1321 Lady Street

DESIGN/DEVELOPMENT REVIEW COMMISSION
DESIGN REVIEW DISTRICT
HISTORIC AGENDA
EVALUATION SHEET
Case # 2

ADDRESS: 1321 Lady Street, Owen Building

NATURE OF REQUEST: Request Certificate of Design Approval for exterior changes and preliminary approval for Bailey Bill

Staff photos above and left, proposed door is in right side of entry above

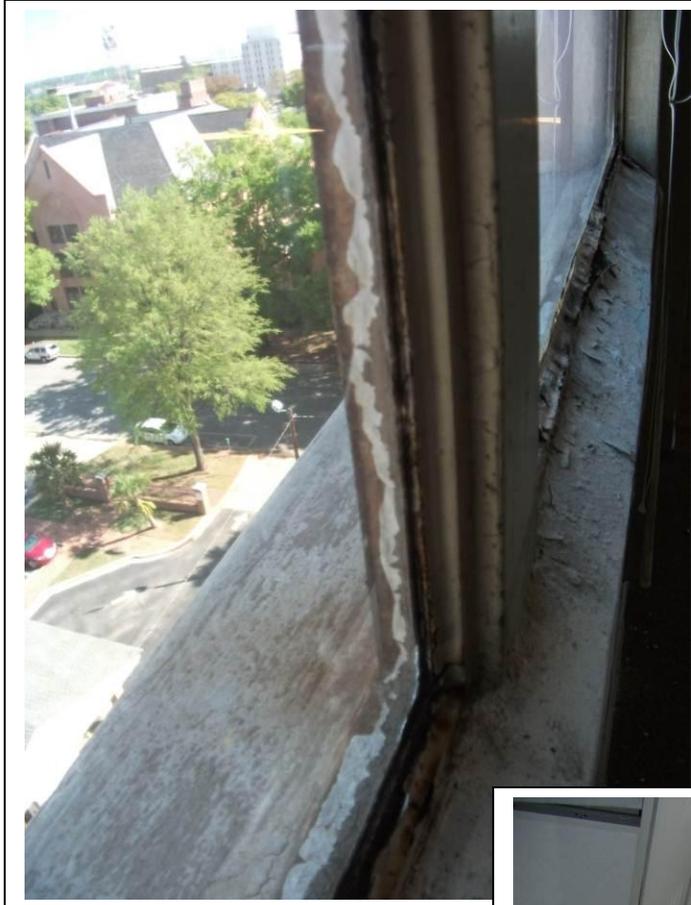
A new door is proposed in the main entry of the annex, along Marion Street. This door is to access a fire control room, but it necessitates the removal of original cast stone along the side wall of the recessed entry. The proposal is for a steel door that will “be painted to match the stone and the height of the door will align with the seam in the stone.” As this will necessitate the removal of the cast stone in the only surviving original street entryway on this building, it does not meet this ordinance. The use of a mass of cast stone in a solid plane is a material juxtaposition against the brick that should remain intact as an original design feature; this is the largest section of cast stone on the annex. The door should be

moved to the interior of the building. If further discussion with the City's Fire Marshal and Plans Examiner reveal this to be the only location of a doorway for the room, details of the door could be worked out with staff.

- the original glass in the windows be retained and that missing glass be replaced in kind where visible to the public right of way, with clear glass or clear security glass
- that the window frames be restored and repaired in kind with matching materials and profiles
- that the proposed door in the recessed entry on Marion Street be removed
- all details deferred to staff

1321 Lady Street Windows

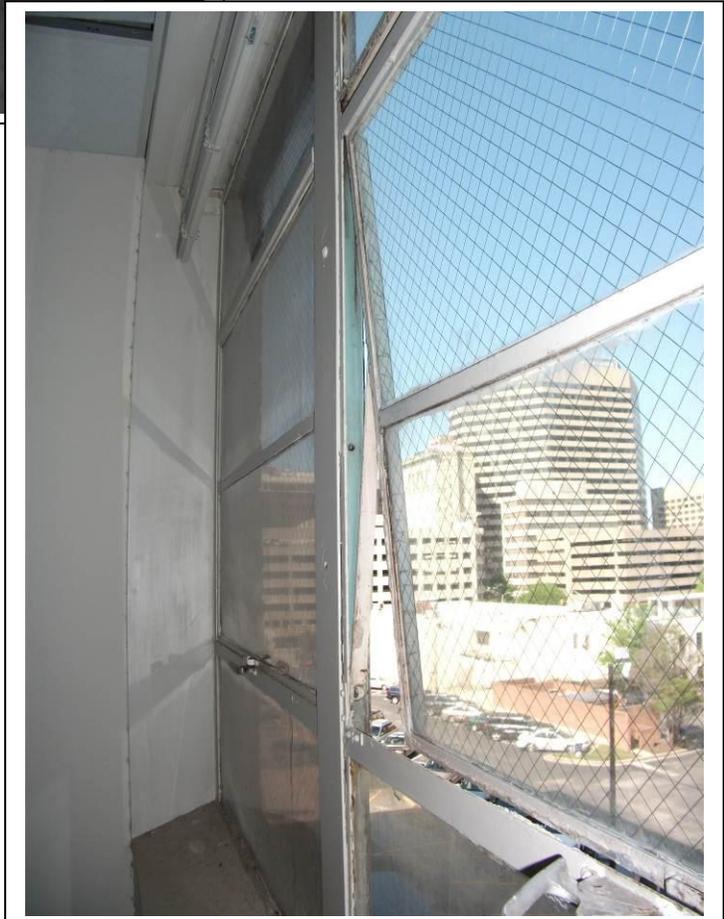
The steel window framings will be restored, but the current proposal is to remove all of the glass in these windows in both the main building and the annex. There is a large degree of ¼" thick security wire glass throughout two sides and rear of the original building, although over the years some of it has clearly been replaced with clear glass or a diagonal pattern wire glass, which is the same glass found in all of the windows of the annex except those on the facade. The thickness of the security glass is twice the normal thickness of window glass.

A lot of the original wire glass has been coated in a film, although there are some areas where this is failing. This suggests it may be possible to remove the film and use the existing glass. The use of clear glass on the front of the building is also distinctive, as this was the side of the building not near another structure and therefore not needing the security glass in the windows.

Windows: There are some broken glass panes throughout the building and the metal frames have rust in many locations. The proposal is to restore the metal framing. Also proposed are replacement glass units insulated with a low-emissivity tinted coating. In historic images of the Owen building the windows appear very clear and it is likely they had no tinting. In areas where the steel windows have deteriorated the steel should be repaired. If the deterioration and rust has made a piece of the window framing lose its structural integrity and it cannot be repaired, then that section of the steel window should be replaced with a matching piece to meet this guideline.

Likewise, where the original glass is missing or broken, it should be replaced in kind in order to meet this guideline. In windows that originally had wire glass it should be replaced with the same.
